TECHNICAL DOCUMENT TO SUPPORT THE CENTRAL EVERGLADES PLANNING PROJECT EVERGLADES AGRICULTURAL AREA RESERVOIR WATER RESERVATION

Draft Report

South Florida Water Management District
West Palm Beach, FL

Figure 4-2. Modeled hydroperiod during long-term (1965 to 2005) average rainfall (top) and dry (bottom) year conditions for the existing conditions baseline (left) and Alternative C240 (right).

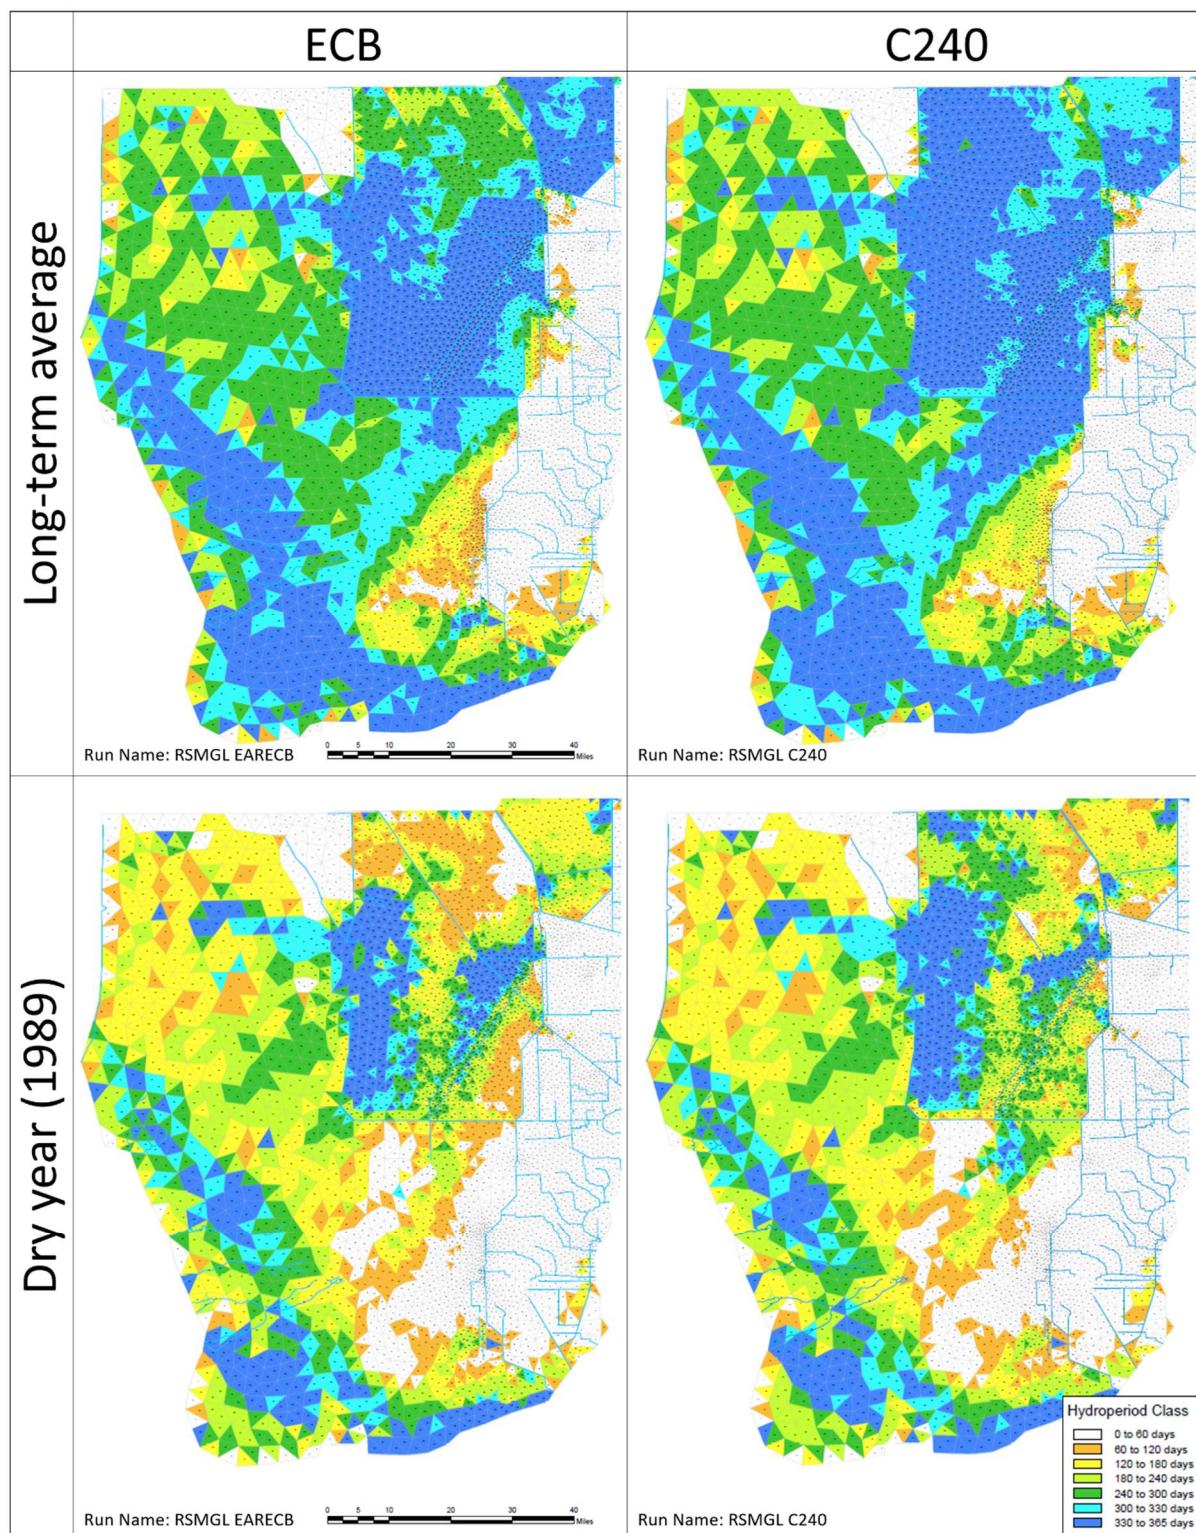
During the presentation period the SFWMD also responded to the concerns about WCA 3B. The general evaluation of hydroperiods, what was Fig. 4-2 in the original report, was replaced by a new figure in the public presentation that demonstrated hydroperiod shifts for a longer period of record than just an average or dry year. The updated figure clarified some small benefits of lengthened hydroperiods and deeper water in WCA 3B (south and central). The problem caused by additional drying out northern WCA 3B was acknowledged and discussed as an area for adaptive management and/or a future project.

Figure 4-16. Average annual overland flow across Transect 18 in Northeast Shark River Slough.

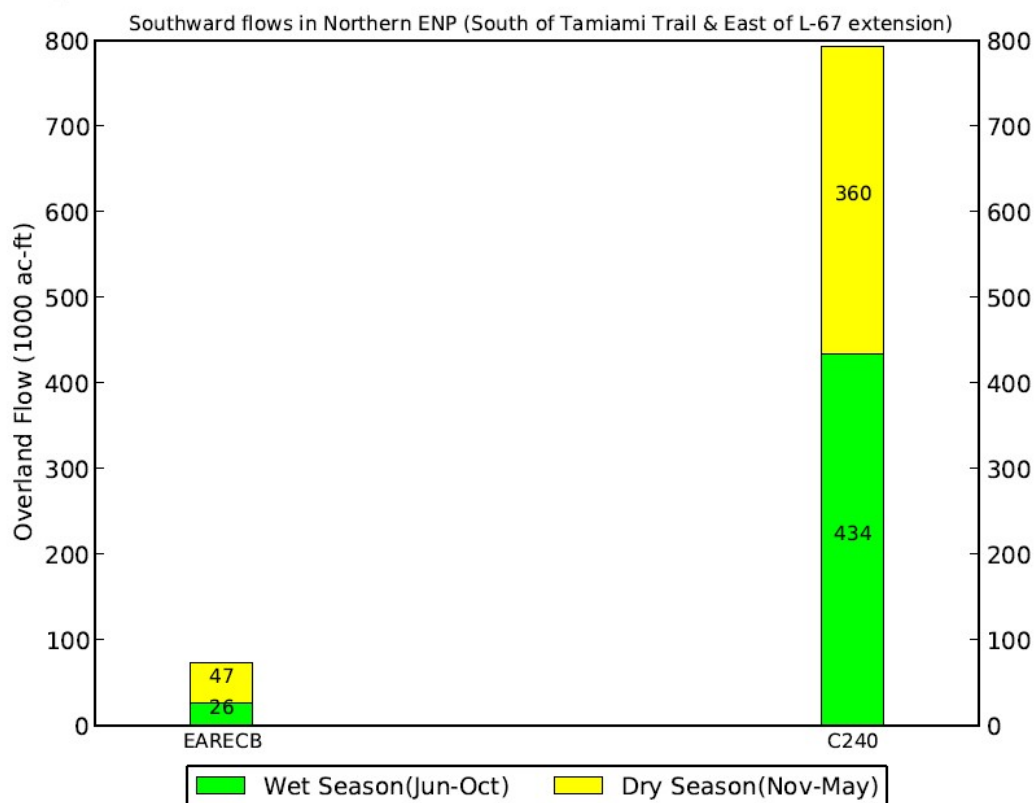
90	Dr. Donald DeAngelis (Peer Reviewer)	What is meant by Segment head (Figure 4-16)?	Clay Brown: Figure 4-16 is a stage-duration curve representing the headwater at structure S334. The vertical axis of the graph is canal stage with vertical datum units of NGVD29, ft. The term "segment" is a modeling term that refers to the discretization of a real-world canal system into modeled "segments". Output for canal segments can be reported as flow or stage; the term "head" is often used in place of stage. Dong Yoon Lee: We will revise the caption of Figure 4-16 (Segment head --> Canal stage).
